Patentees: James George Allen et al
Patent No. 7,,093,544 B1
Issued: January 6, 2004 September 29, 2006
Title: Control Device For A Railroad Car

REQUEST FOR A CERTIFICATE OF CORRECTION

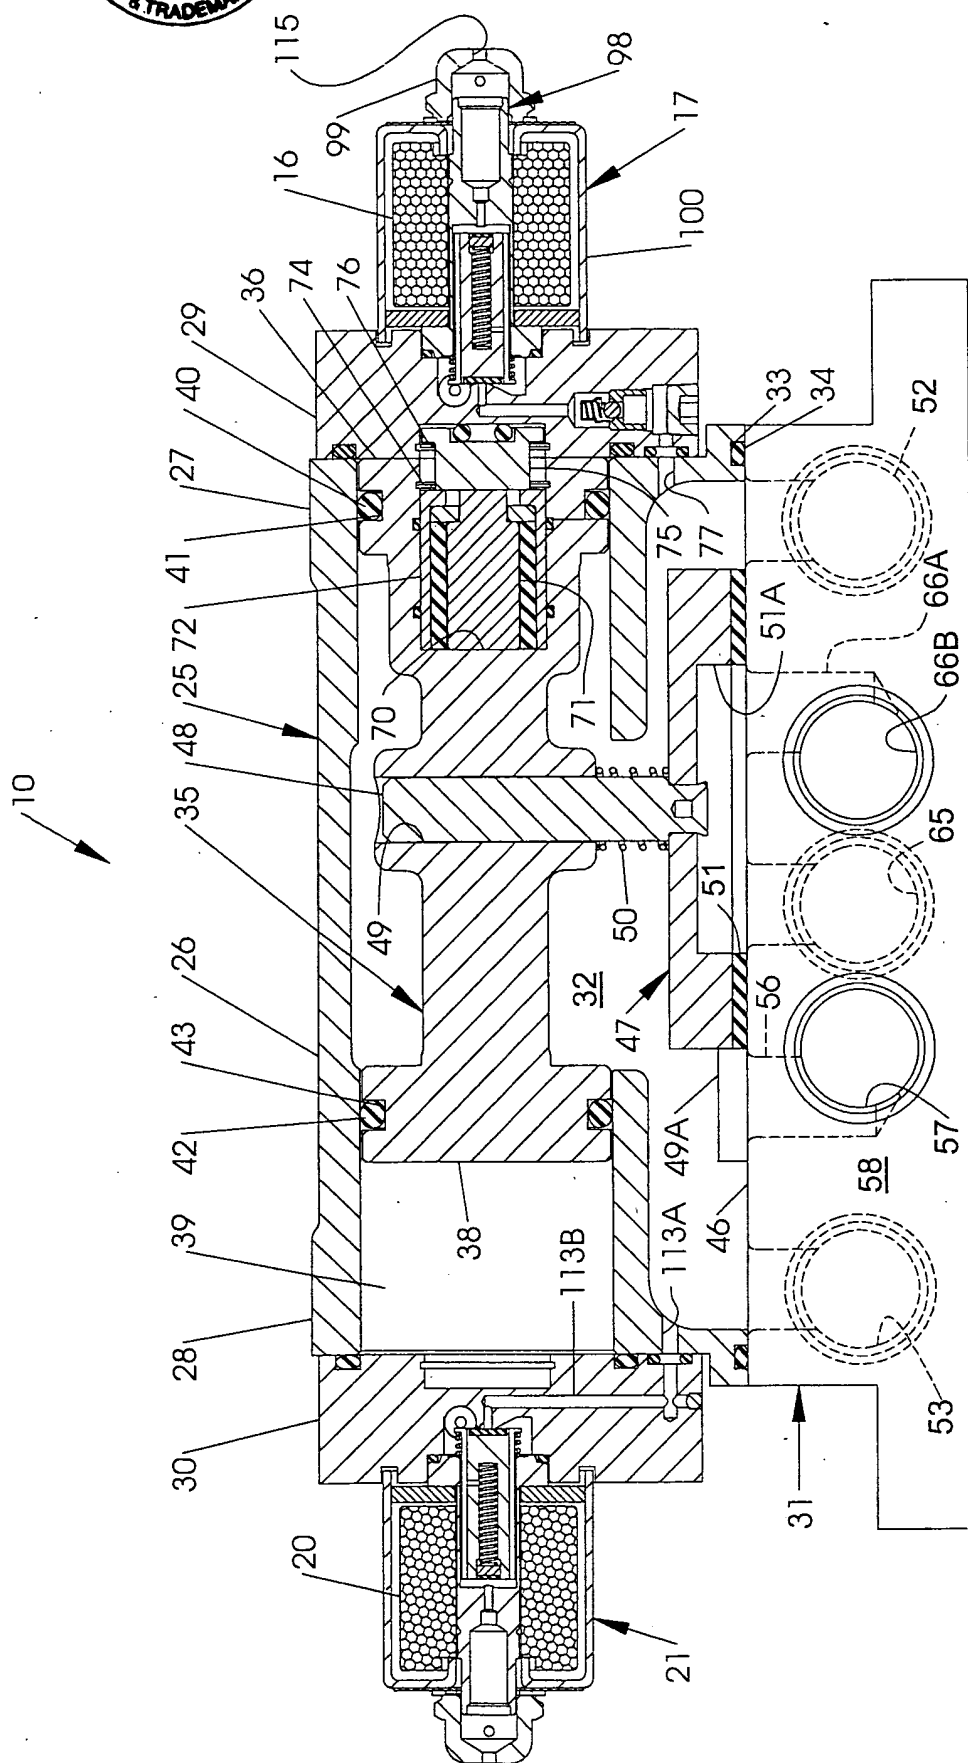
The error in FIG. 1 is that it did not show passages 113A and 113B communicating as described in column 6, lines 54-57 (page 16, lines 10-13 of the application) and as shown in original FIG. 9 but not numbered. These numbers have been added to new FIG. 9. This is not new matter in view of both original FIG. 9 and the specification disclosing this communication.

Delete FIGS. 1, 8, and 9 and substitute included FIGS. 1, 8, and 9

FIG. 8

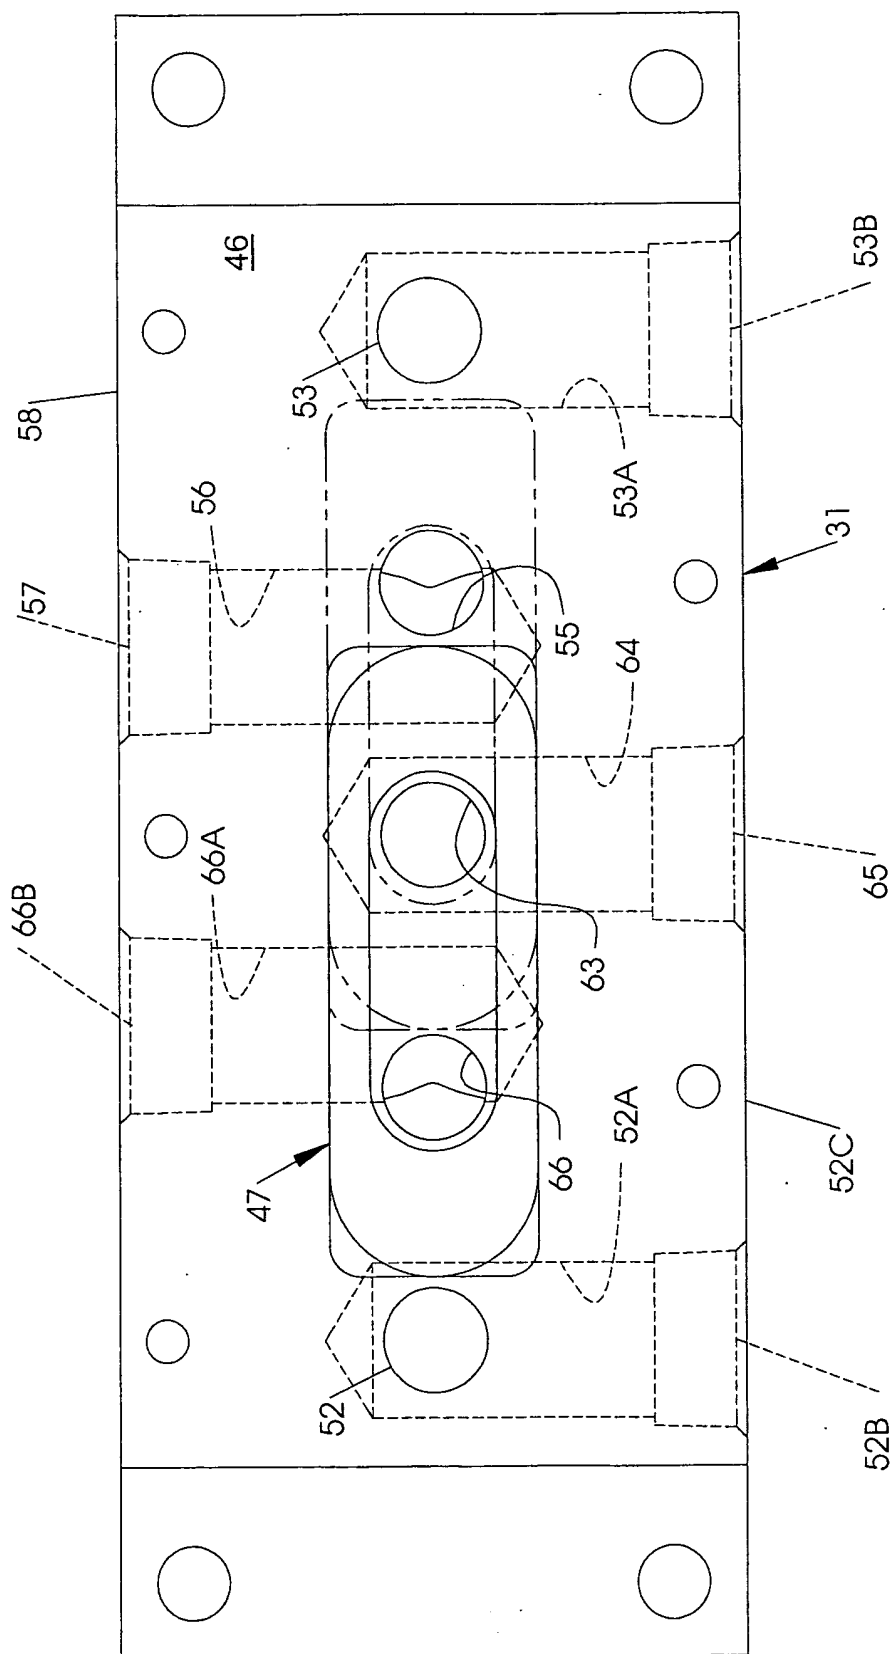
Corrected FIG. 8 adds 53A to identify a passage in plate 31 as described in column 4, line 39 (page 10, line 24 of the application) and as shown in original FIG. 9. This is not new matter.
